W.O. No. 4203

New "Cigar Style" pylon sign by Adcon for LL. Pylon faces only for Chipotle under this W.O.

Store #4098
1103 SW Oldham Parkway
Lee's Summit, MO 64081

Design Proposal for:
Chipotle Mexican Grill
South Lee's Summit
Store #4098
1103 SW Oldham Parkway
Lee's Summit, MO 64081

Design Proposal for:
Chipotle Mexican Grill
South Lee's Summit
Store #4098
1103 SW Oldham Parkway
Lee's Summit, MO 64081

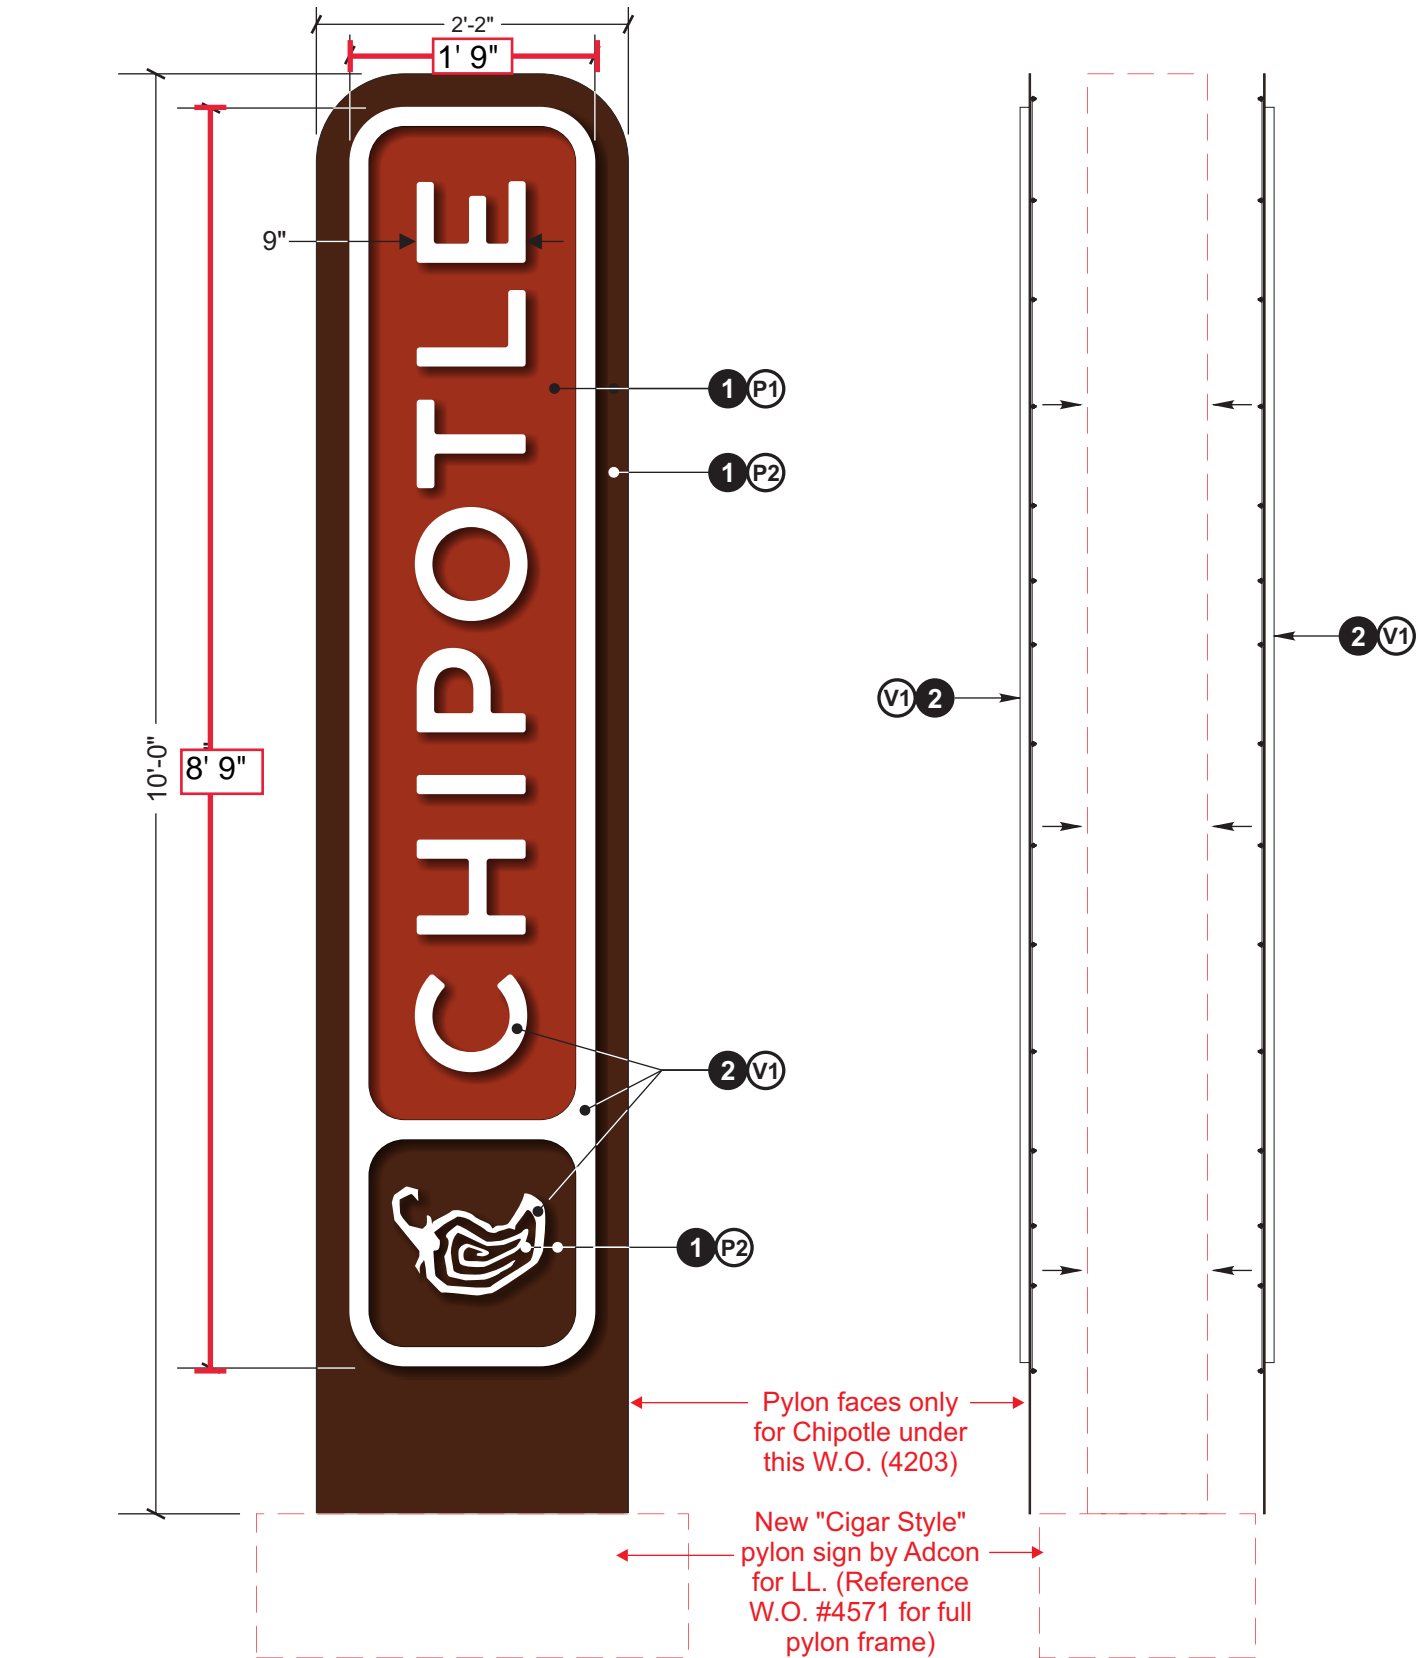
Resized for 11' pylon size
